**REVISED RESPONSE TO REQUEST FOR ADDITIONAL INFORMATION****APR1400 Design Certification****Korea Electric Power Corporation / Korea Hydro & Nuclear Power Co., LTD****Docket No. 52-046**

**RAI No.:** 131-8087  
**SRP Section:** 11.05 - Process and Effluent Radiological Monitoring Instrumentation and Sampling System  
**Application Section:** 11.05  
**Date of RAI Issue:** 08/07/2015

**Question No. 11.05-1**

**Figure 11.5-2Z Location of Radiation Monitors at Plant (Turbine Generator Building El. 170'-0")**

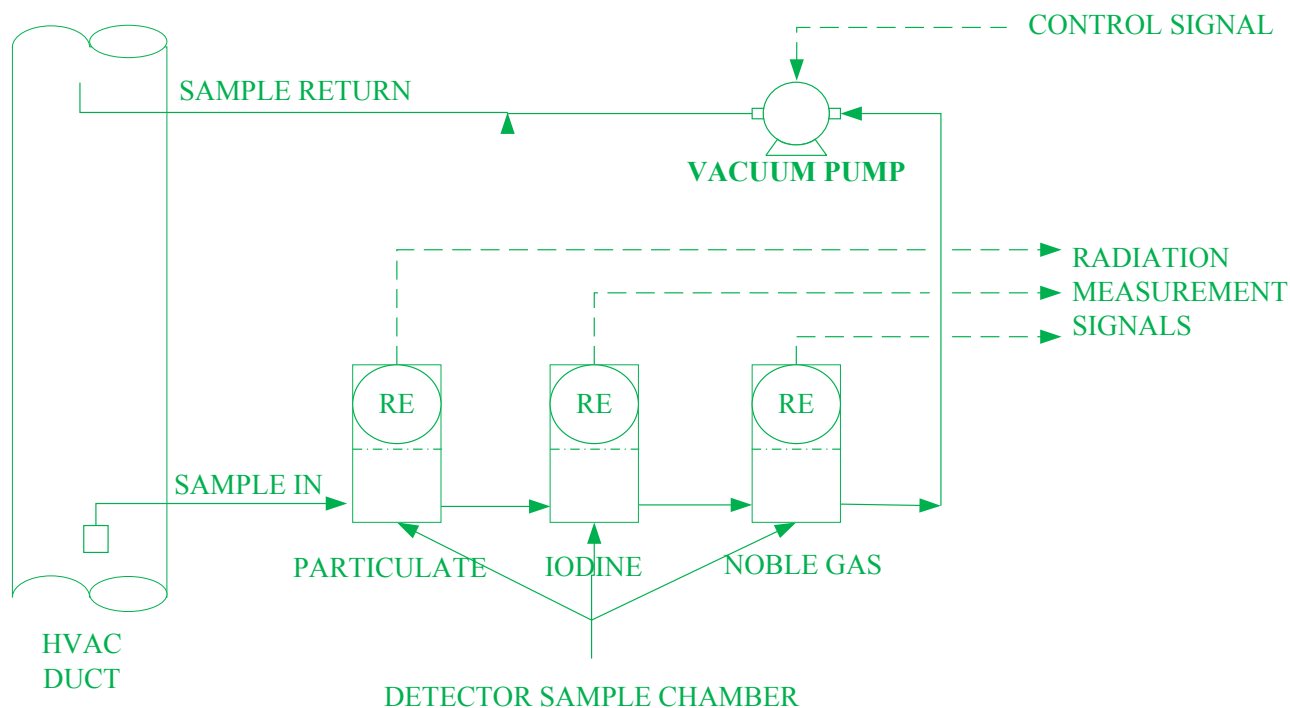
DCD Tier 2, Subsections 11.5.2.2, 11.5.2.3, 11.5.3, 11.5.4 and Table 11.5-1, Figures 11.5-2E, 11.5-2F, 11.5-2G, 11.5-2H, 11.5-2I, 11.5-2J, 11.5-2K, 11.5-2L, 11.5-2M, 11.5-2O, 11.5-2P, 11.5-2Q, 11.5-2U, 11.5-2V, 11.5-2W, 11.5-2Z, and 11.5-2BB will be revised.

The monitor is located in Turbine Generator Building as shown in Figure 11.5-2Z.
